# Design Review (设计评价) 变更提案的实例

Engineering Proposal Sheet

Model	DWG / Part No.	Name / Area	Month	Date	Year
S 197	ADD NEW PARTS	CROSS MEMBER TO TOE BOARD (E-0174 is replaced by this)	7	26	02
Prepared			S. HINA		
Approved			M		
Status			Priority

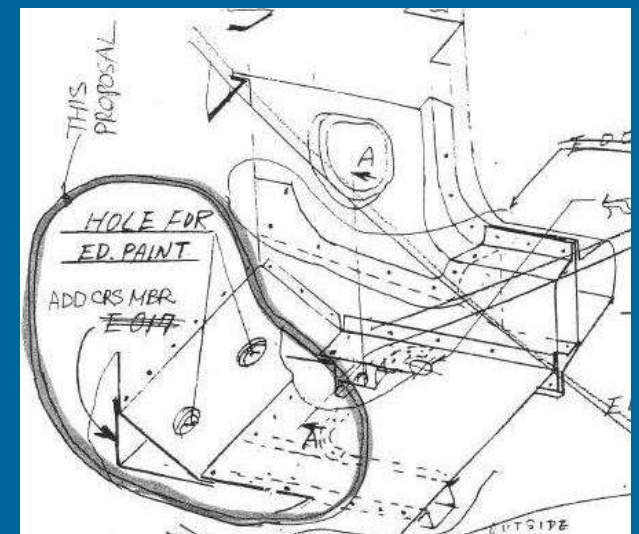
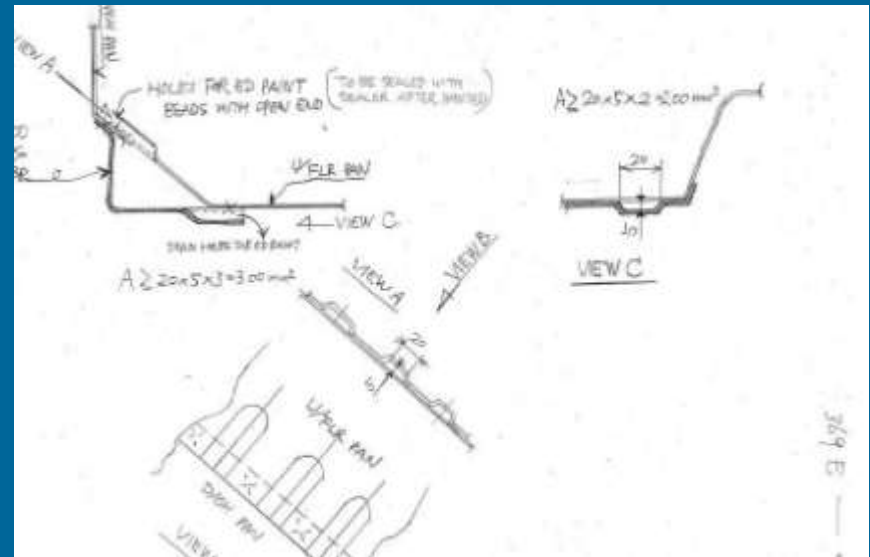
LACK OF STIFFNESS AROUND TOE BOARD.  
BOOMING NOISE MAY OCCUR.  
RESONANT IMPEDANCE SHOULD BE ABOVE 20Hz.  
(CURRENTLY GUESSED BELOW 15Hz.)

To ADD CROSS MEMBER ON TO UNDERSIDE OF TOE BOARD PORTION.  
ALSO THE NEW CLOSED SECTION NEEDS ED PAINT VENT HOLES AND DRAINS.

Adding X MBR is not necessary since there are two X-MBRs on dash
